2.0 SITE CHARACTERISTICS

2.1S Geography and Demography

Section 2.1 of the South Texas Project (STP) Units 3 and 4 combined license (COL) FSAR incorporates by reference Section 2.1 of the certified Advanced Boiling-Water Reactor (ABWR) design control document (DCD) Revision 4, referenced in Title 10 of the *Code of Federal Regulations* (10 CFR) Part 52, "Licenses, Certifications, and Approvals for Nuclear Power Plants," Appendix A, "Design Certification Rule for the U.S. Advanced Boiling Water Reactor," with no departures. In addition, in FSAR Section 2.1S.1, the applicant provides site-specific information on site location and a description that addresses COL License Information Item 2.3 as summarized below:

Figure 2.3S.2-1 Comparison of 1997, 1999, and 2000 Wind Direction Frequency Distributions

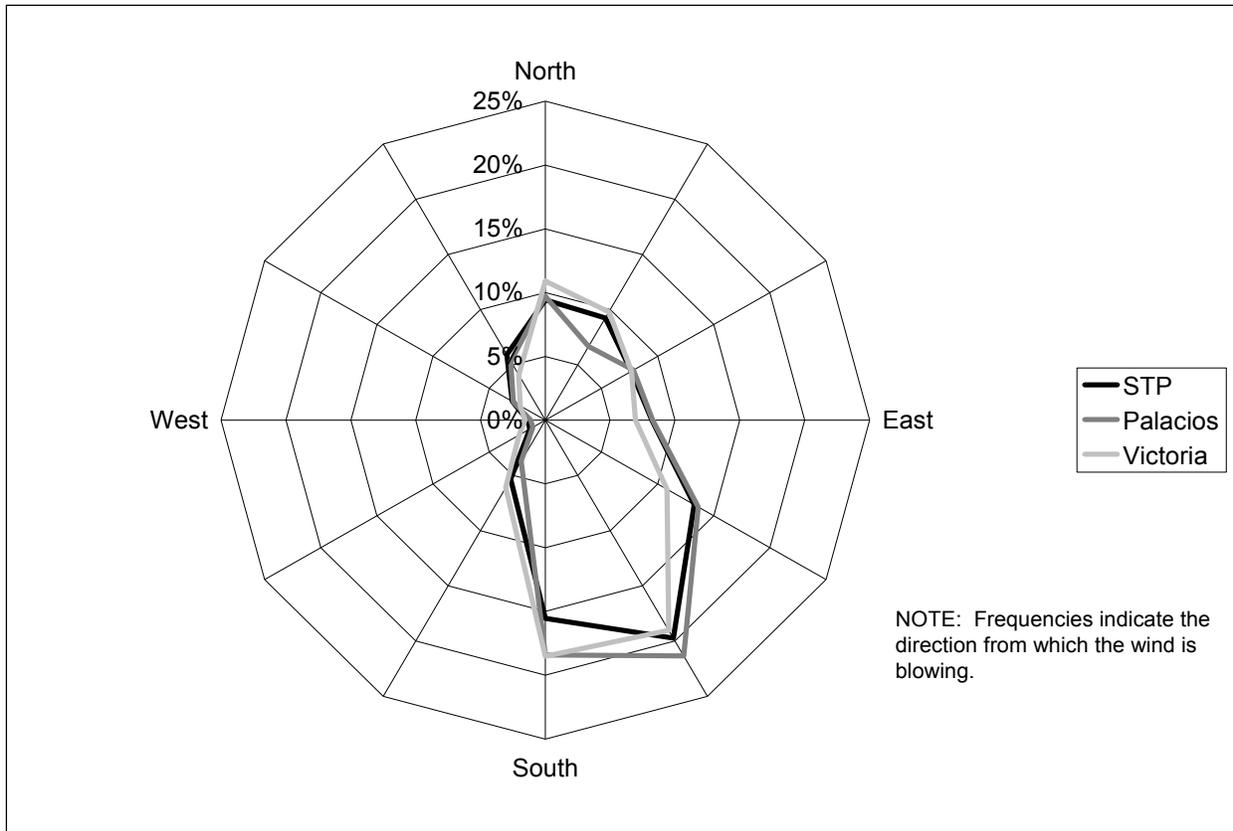
In order to confirm this hypothesis, the staff generated a comparison of annual wind direction frequencies among the STP, Palacios, and Victoria hourly data for the years 1997, 1999, and 2000. This comparison, shown in SER Figure 2.3S.2-1, indicates a similar distribution among all three sites. The staff also compared annual average wind speeds among all three sites for the same three-year time period. The staff found that the STP 10-m (33-ft) level average wind speed of 4.1 m/s (13.5 ft/s) is consistent with the 6.1-m (20.0-ft) level average wind speed of 4.1 m/s (13.5 ft/s) at Victoria but somewhat lower than the 5.0 m/s (16.4 ft/s) average wind speed recorded at Palacios. The staff issued **RAI 02.03.02-4a** requesting the applicant to justify not including meteorological data from Palacios in the review of average wind direction and wind speed conditions discussed in Revision 0 of FSAR Tier 2, Section 2.3S.2.2.1.

Figure 2.3S.3-3 STP Stability Class Frequency Distributions.

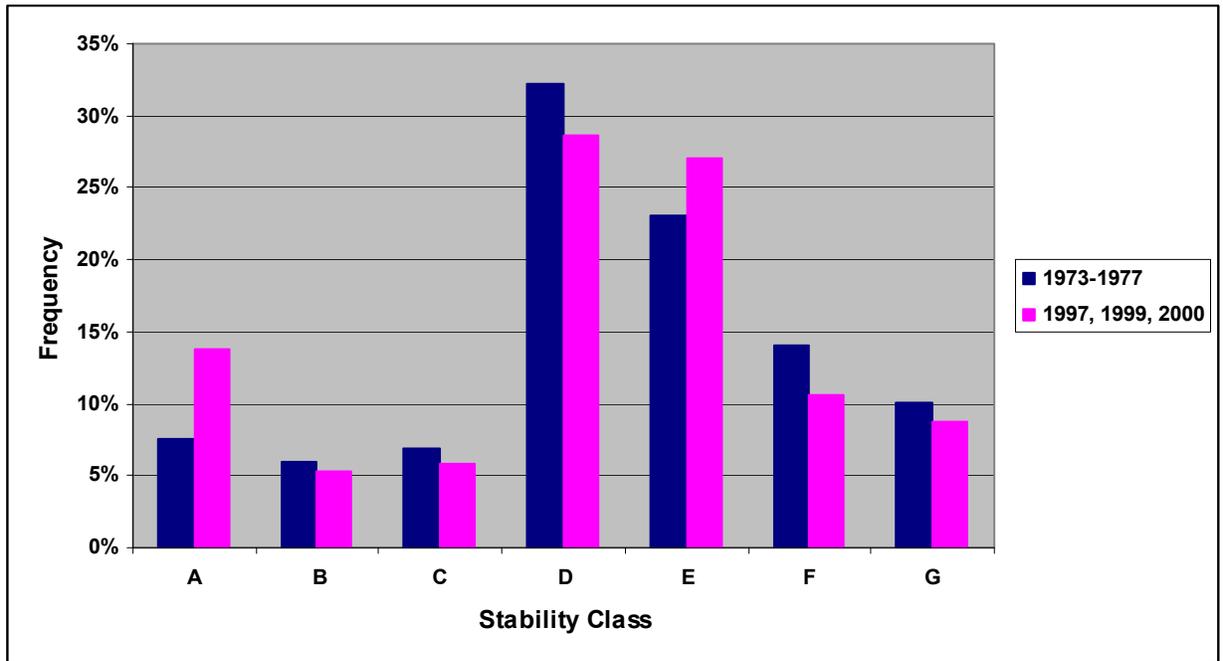
The stability class frequency distribution for both data sets in SER Figure 2.3S.3-3 also show reasonable agreement. Nonetheless, the staff issued **RAI 02.03.03-3** asking the applicant to explain the 6 percent frequency increase of onsite Stability Class A (extremely unstable) conditions from the original data set to the current data set (see SER Figure 2.3S.3-3).

Figure 2.3S.3-4 STP Stability Class A Frequency Distribution.

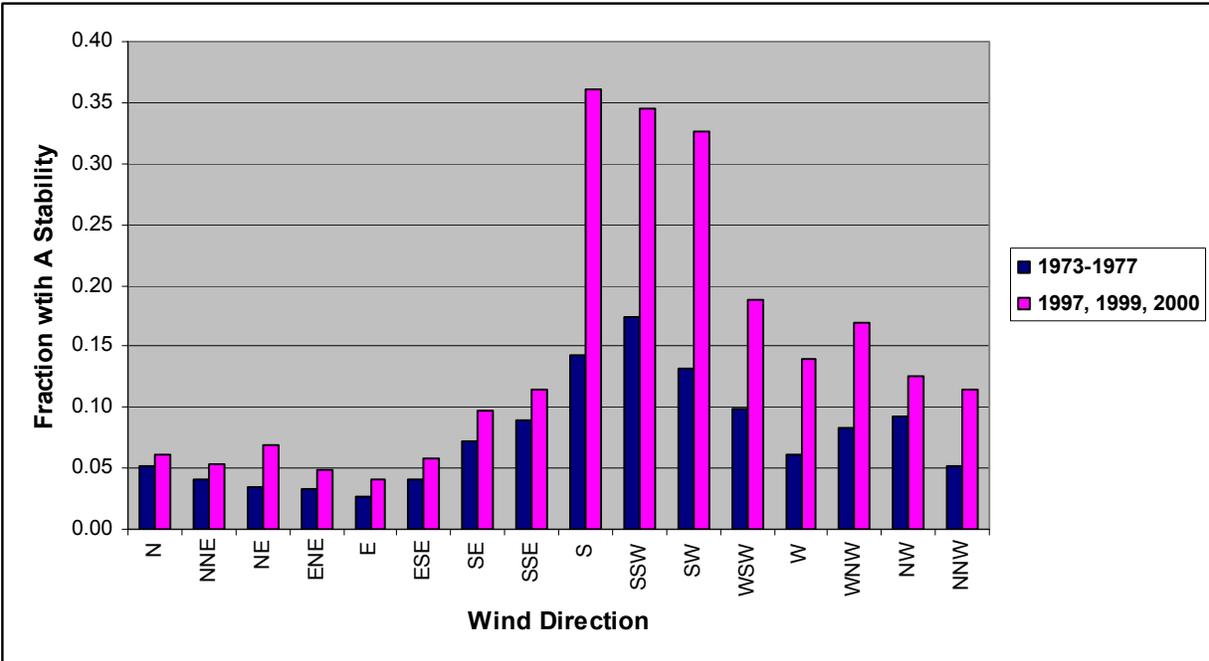
the 1997, 1999, and 2000 data represent the STP Units 1 and 2 post-operational period. The main cooling reservoir is located approximately 1.6 km (1 mi) south-southwest of the main cooling reservoir. SER Figure 2.3S.3-4 shows that Stability Class A increased primarily in the south-through-southwest wind direction sectors for the STP Units 1 and 2 post-operational period. Therefore, the applicant mainly attributes the 6 percent frequency increase of onsite Stability Class A to the thermal instability contributed by the main cooling reservoir. The staff found this assessment reasonable and considers **RAI 02.03.03-3** closed.
